Errata Sheet

NACE Standard TM0177-96

Users of NACE Standard TM0177-96 should make the following changes:

Laboratory Testing of Metals for Resistance to Specific Forms of Environmental Cracking in H₂S Environments

Figure 10
DCB Specimen

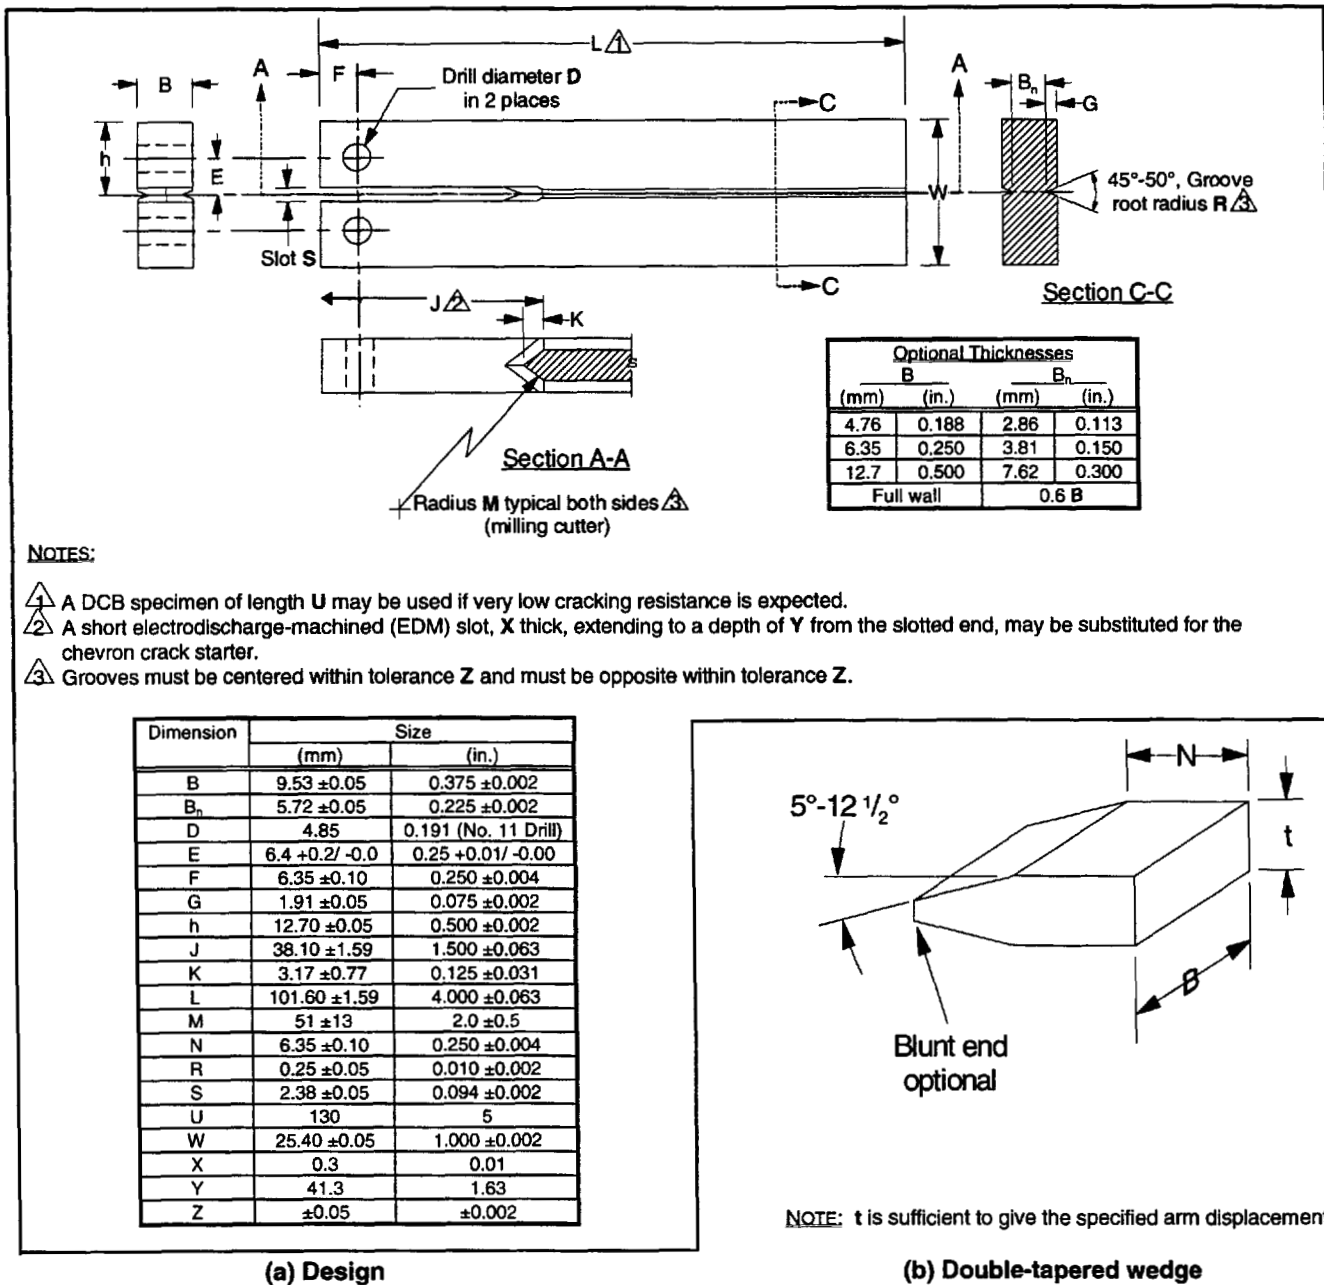
- (1) Paragraph 9.5.1: The second sentence should read: "For carbon and low-alloy steels, S_c values are typically in the range of 69 MPa (10⁴ psi) at 22 to 24 HRC." (The changed portion is underlined.)
- (2) In Figure 10(a), the J arrow should be extended to the left as shown:
